Access Compliance Report

Public Rights-of-Way

Intersection ID: 15377	Main Street: ELMHURST_RD	Cross Street: HAVERFORD_PL	Location: E
ADA ID: 53793914A370	Ramp Type: PerpDiag	Initial Pass/Fail: Fail	Overall Compliance: No
			Severity Score: 28.75

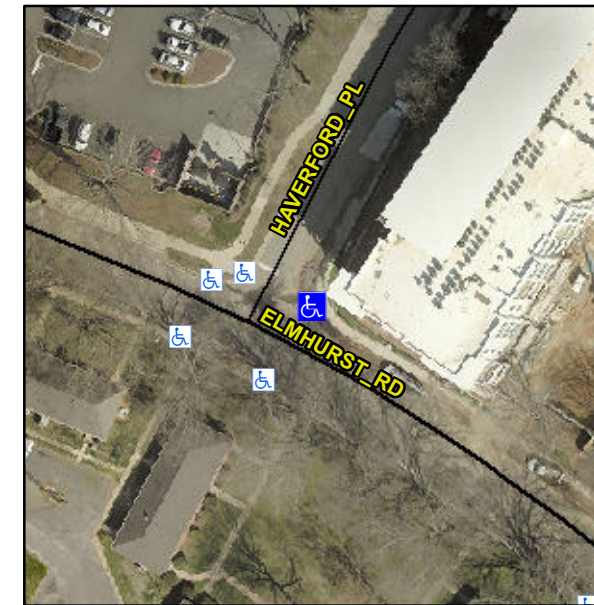
Not Found, R304.2.2, R304.5.3, R302.7

Compliance	Description	Data	Compliance	Description	Data
N/A	Ramp Length (in)	61.0	No	Ramp Slope (%)	9.2
Yes	Ramp Width (in)	60.0	No	Ramp XSlope (%)	2.5
N/A	Flare Type LT	N/A	N/A	Flare Type RT	N/A
N/A	Flare Slope LT (%)	N/A	N/A	Flare Slope RT (%)	N/A
N/A	Flare Traversable LT?	N/A	N/A	Flare Traversable RT?	N/A
N/A	Landing Length (in)	N/A	N/A	DWS Provided?	N/A
N/A	Landing Width (in)	N/A	N/A	DWS Contrast?	N/A
N/A	Landing Slope (%)	N/A	N/A	DWS Length (in)	N/A
N/A	Landing X Slope (%)	N/A	N/A	DWS Full Width?	N/A
N/A	Landing Curb? (Y/N)	N/A	N/A	DWS Offset (in)	N/A
N/A	Shared Landing?	N/A			
N/A	Gutter Ponding?	N/A	N/A	Gutter Slope (%)	N/A
N/A	Gutter Lip Ht (in)	N/A	N/A	Gutter X Slope (%)	N/A
N/A	Painted X Walk1?	No	N/A	Painted X Walk2?	No
	X Walk 1 Direction	To NW		X Walk 2 Direction	To SW
N/A	X Walk 1 Width (in)	N/A	N/A	X Walk 2 Width (in)	N/A
	X Walk 1 Slope (%)	2.8		X Walk 2 Slope (%)	0.1
	X Walk 1 X Slope (%)	1.9		X Walk 2 X Slope (%)	1.2

Remove & Replace Curb Ramp With Two New Directional Ramps or Equivalent.
